Geology and Earth

I am submitting to you another comment packet regarding Glacier Northwest's expansion proposal for the Mats Mats Quarry. It does contain comments on the pages your department recently mailed out, which caused an extension of the comment period to April 8, 2002. If you have any questions, please contact me.

Response to Letter 8

MATS MATS AREA COALITION (March 27, 2002)

Freshwater Lens Effect in Island Hydrology

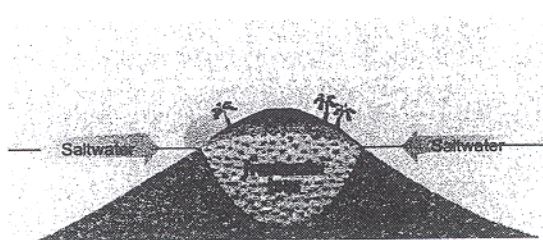
I tried to educate myself about freshwater-lens systems. The most meaningful information came from a site explaining how they work in Hawaii. What I found most interesting was that they are found, not created, by man. A freshwater-lens system includes a lens-shaped freshwater body, an intermediate zone of brackish water, and underlying saltwater. Freshwater-lens systems are recharged by direct infiltration of precipitation and irrigation water, and by inflow from upgradient ground-water systems. At the quarry site, we only have the element of precipitation. Is 23-27 inches of rain enough to keep out the saltwater?

35. The dynamics of a freshwater lens system is site-specific, and is often associated with island groundwater conditions as noted in the comment. Although the Mats Mats Quarry is surrounded on three sides by marine water, interpretation of the regional hydrogeology indicates the freshwater/saltwater interface beneath the quarry occurs as a coastal wedge system. Therefore, the dynamics of a freshwater lens system is not directly applicable for evaluating existing groundwater conditions beneath the site. The *Groundwater* section and *Appendix I* of this Final EIS includes (1) a detailed description of the conceptual hydrogeologic model for the site and vicinity, and (2) a discussion of potential changes to the freshwater/saltwater interface beneath the site.
